Docket Nos. 50-348
50-364

Joseph M. Farley Nuclear Plant
Request for Additional Information Regarding
Southern Nuclear Operating Company Responses To
The FNP Electrical Distribution System Functional Inspection
Degraded Grid Voltage Unresolved Item

RESPONSE TO NRC REQUEST FOR ADDITIONAL INFORMATION FOR EDSFI DEGRADED GRID VOLTAGE UNRESOLVED ITEM

Degraded Grid Alarm and Trip Diagram

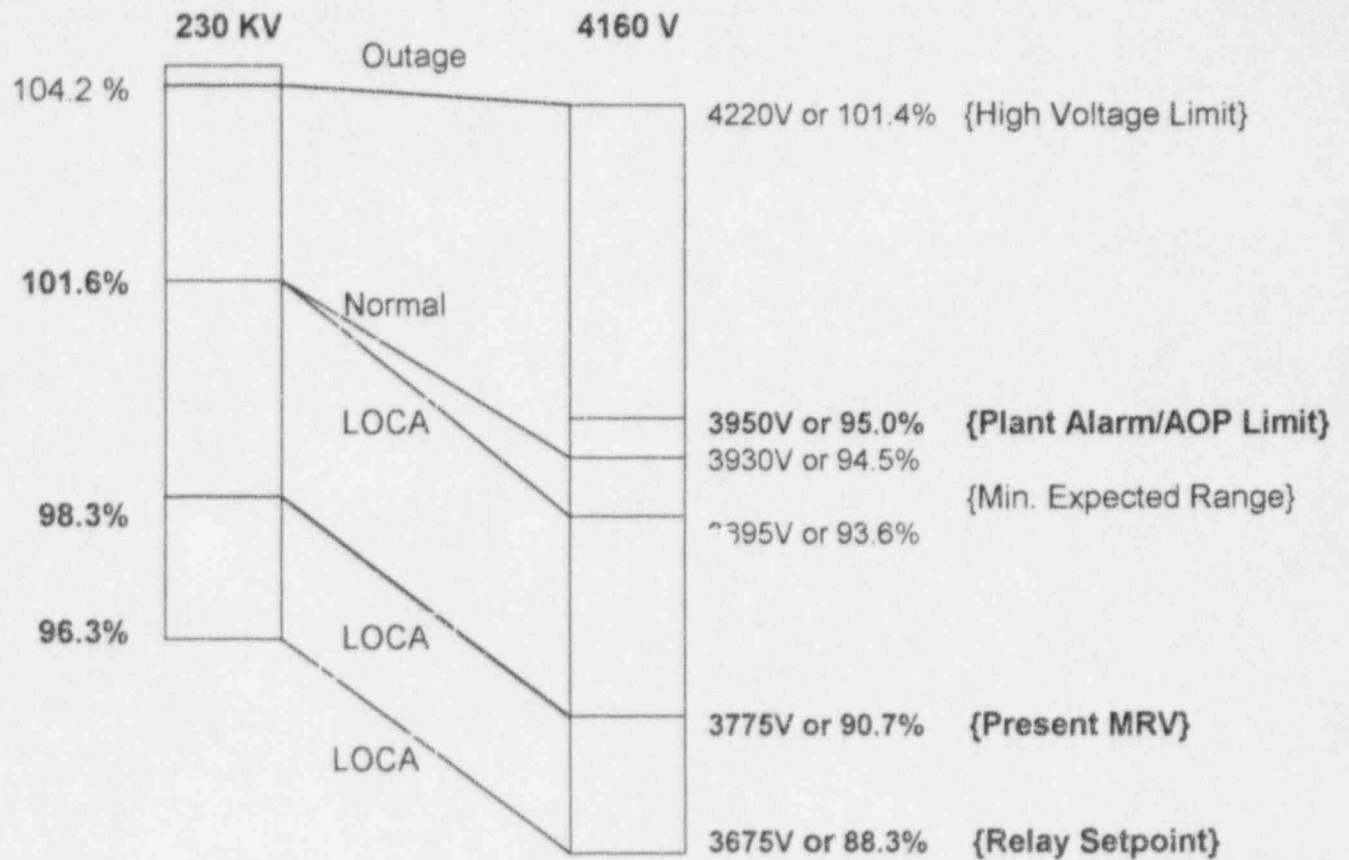
1. Provide the results of the investigation performed to determine the feasibility of raising the degraded grid voltage setpoint.

Response:

(Refer to Attachment 1) The current minimum switchyard voltage required to ensure that adequate voltage will be supplied to all components needed during a LOCA is 98.3% of 230kV. Raising the 4160 volt relay lower tolerance to protect at the present minimum required voltage (MRV) would provide less margin for operational and dynamic voltage excursions such as motor starts or system transients. In consideration of relay accuracy, this would currently place the relay upper tolerance at approximately 101.9% of switchyard voltage which would result in a voltage higher than the minimum expected switchyard voltage. This would be undesirable since this would increase the probability of separating from the preferred power source and tripping the Units when it would be safer to remain on this preferred power source and on line.

(Refer to Attachment 1) The deadband for which automatic protection may not exist for voltages below the current minimum expected switchyard range is currently 88.3% to 90.7% of 4160 volts (3675 to 3775 volts). This deadband (enveloping both trains of both units) represents the range of 4160V safety bus voltages from the degraded grid relay setpoint (3675 volts) to the present MRV (3775 volts). The MRV is the currently calculated voltage at which the required safety loads have been evaluated to start and run, in response to an automatic SI actuation. The maximum loading and minimum voltages for safety-related buses occur in response to an automatic SI actuation. The addition of the SI actuated loads to the normal bus loading results in approximately 1% lower 4160V bus voltage, for a given 230kV switchyard voltage.

Protection is afforded by system and plant alarms and the resulting operator actions. The system grid alarm is currently set at 101.6% of 230kV. This alarm monitors both the actual voltage level and the calculated voltage level which would result in the event of the next single contingency (unit trip). In addition, in-plant alarms on the 4160V safety buses are currently set at 95% of 4160 volts (3950 expected minimum range, which provides margin above the MRV of 90.7%). The degraded grid relay protection is set at 88.3% of 4160 volts (3675 volts).
